## **LOT 41 CARDUP SIDING ROAD, CARDUP STORMWATER MANAGEMENT PLAN - ADDENDUM**

This addendum is to support the current Application for Development Approval which includes seeking approval to modify to the overall drainage system on Lot 41 Cardup Siding Road.

PROJECT:  
LOT 41 CARDUP SIDING ROAD  
CARDUP  
DRAWING TITLE:  
STORMWATER DRAINAGE LAYOUT

NOTES

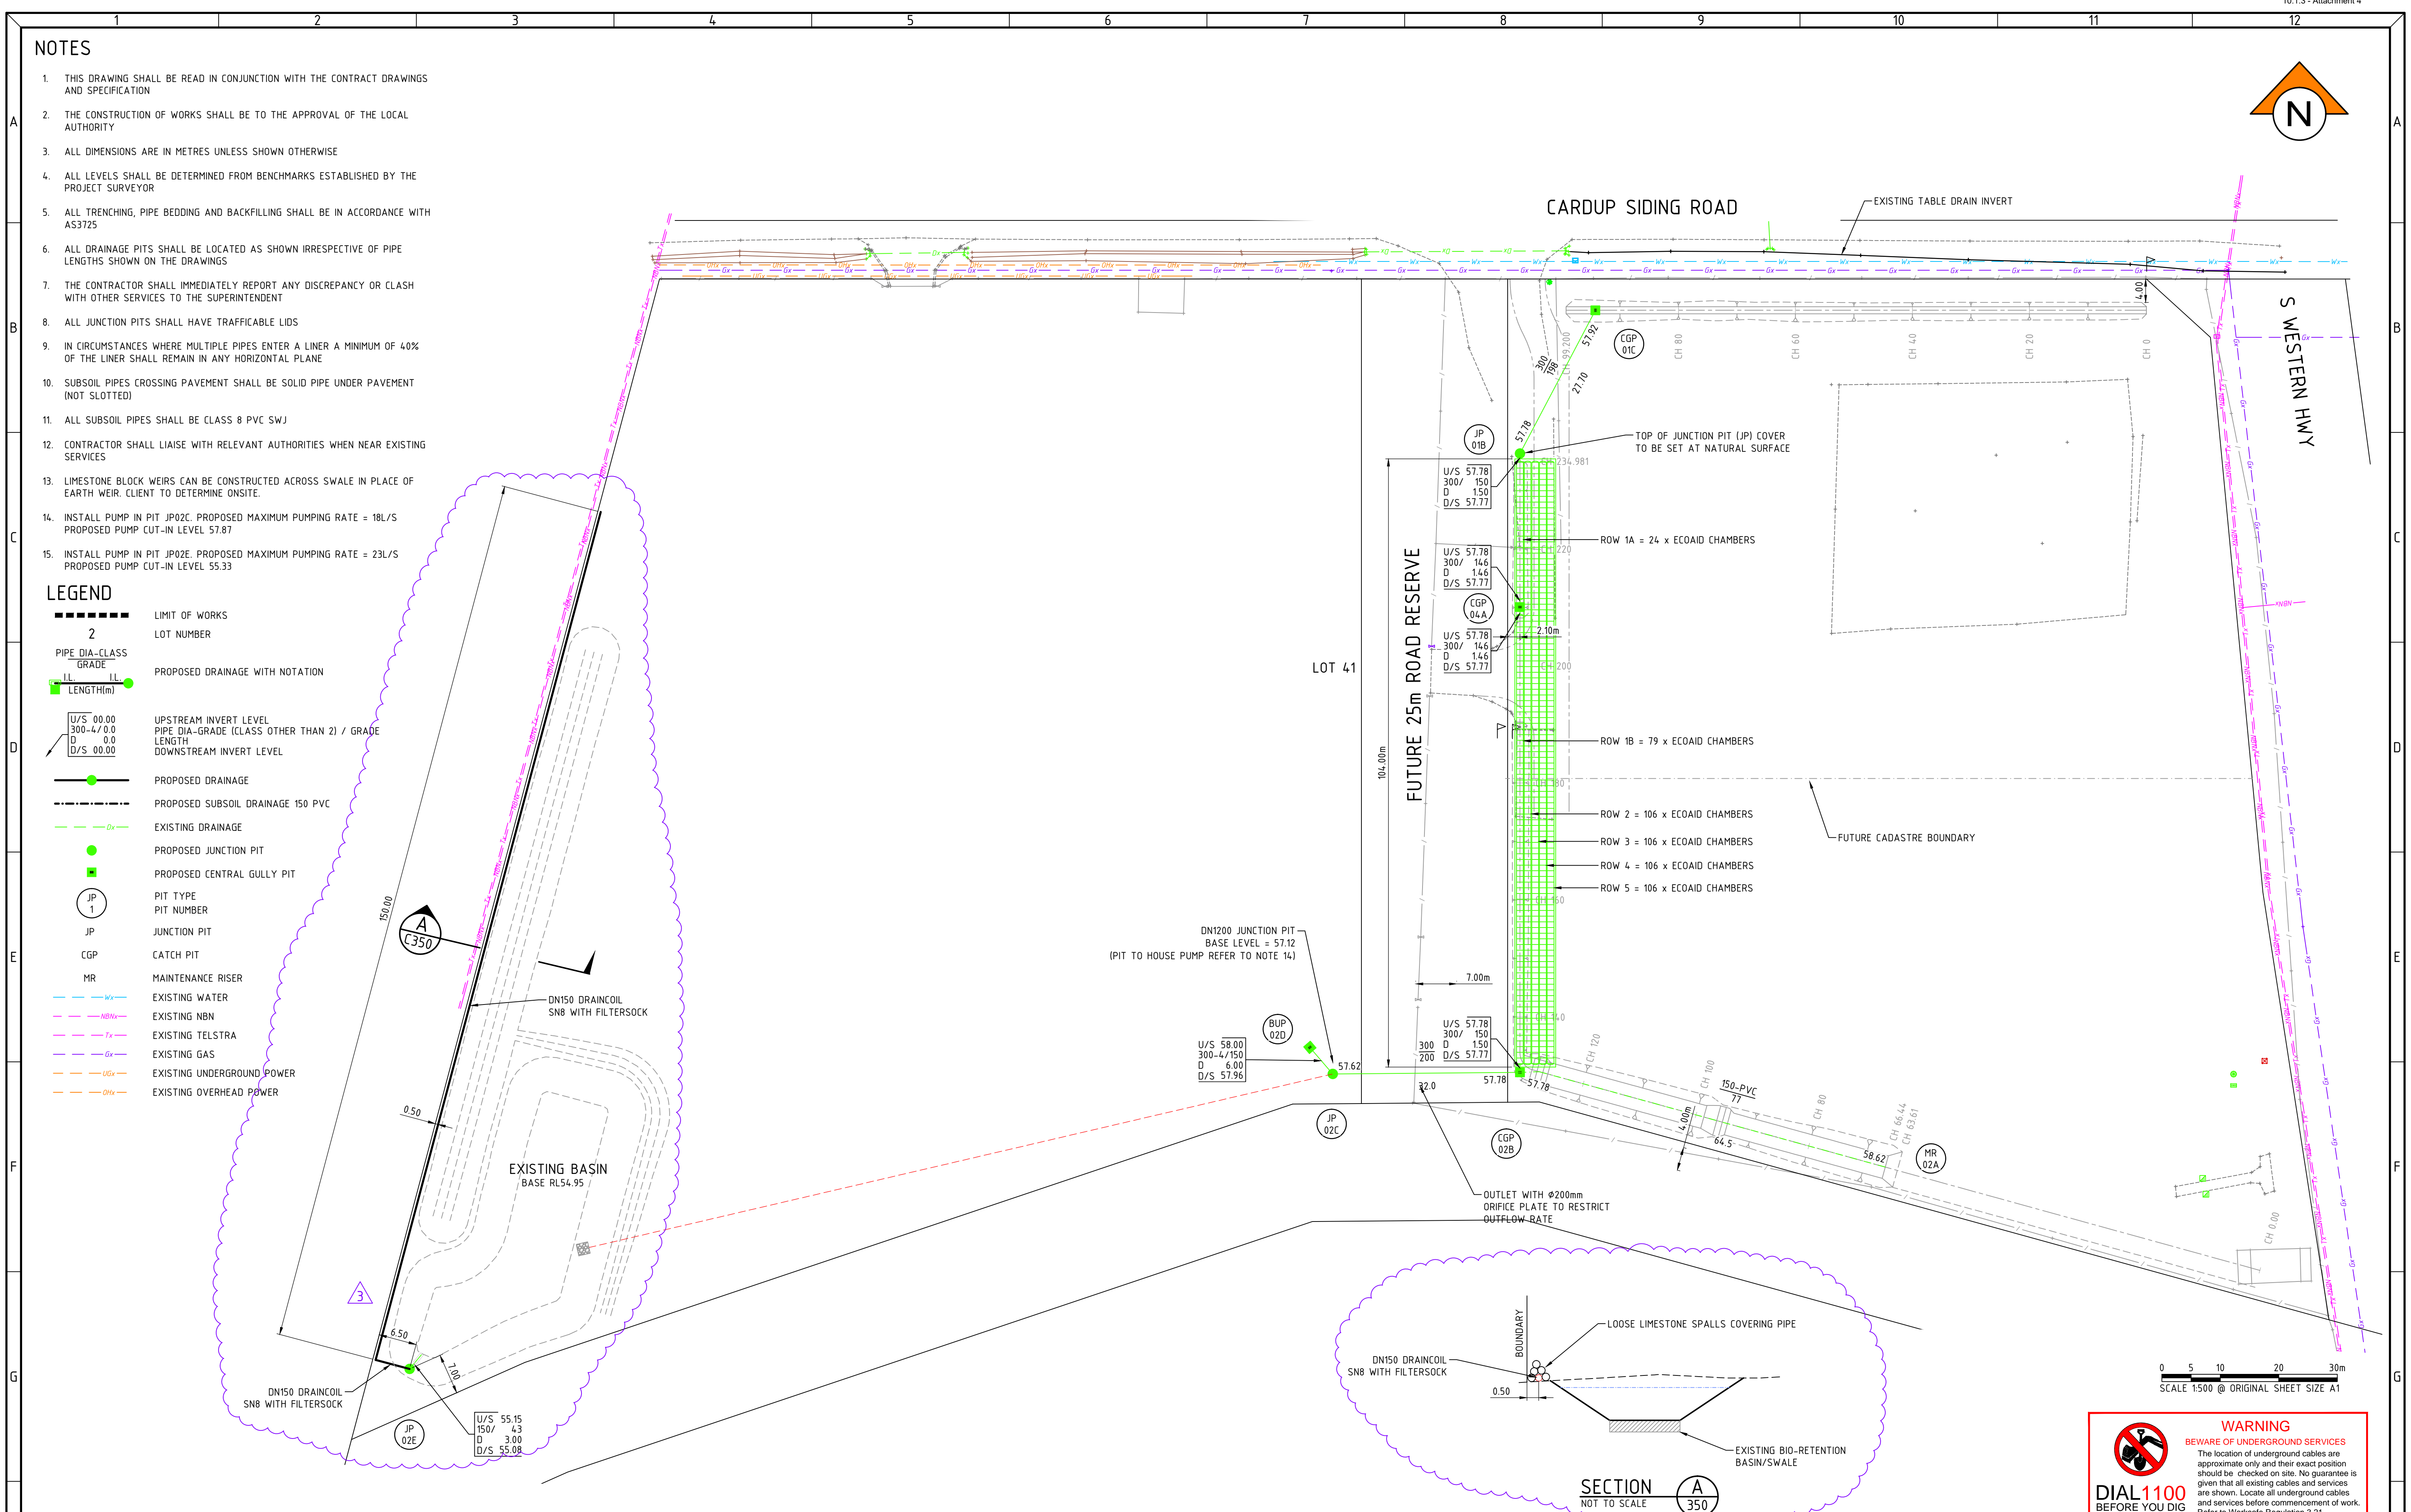
The low infiltration rate was also likely to place similar limitations on the performance of the underground storage tanks. The solution developed with Officers was the provision of two pumps, one to pump water from the underground storage to the basin and one to pump water from the basin (Refer attached **Drawing C350 Rev B**). Both pumps were low flow with the intent being to gradually empty both storages at a controlled rate with discharge less than pre-development flows.

The current design is shown on attached **Drawing C350 Rev 3**.

The design retains the original concept of all drainage in the eastern portion of the site, including the proposed new warehouse development, being directed to the bio retention swales and underground storage units then pumped to the drainage basin to enable gradual emptying.

Drainage of the western portion of the site remains unchanged apart from modification to the discharge from the basin. It is now proposed to gradually discharge stormwater by pumping into a 150mm diameter perforated pipe which extends 150m along the western boundary of Lot 41. The pipe will be wrapped in a filter media (Flitersock) and be contained within loose limestone spalls covering the pipe. This will ensure stormwater slowly discharges along the length of the pipe in a controlled manner with no potential to cause scour.

The basin discharge pump will have a maximum pumping rate of 23 litres per second which is roughly 8% of the calculated pre-development flow. Discharging over the 150m length also mimics the pre-development sheet flow conditions rather than concentrating flow at a single discharge point.
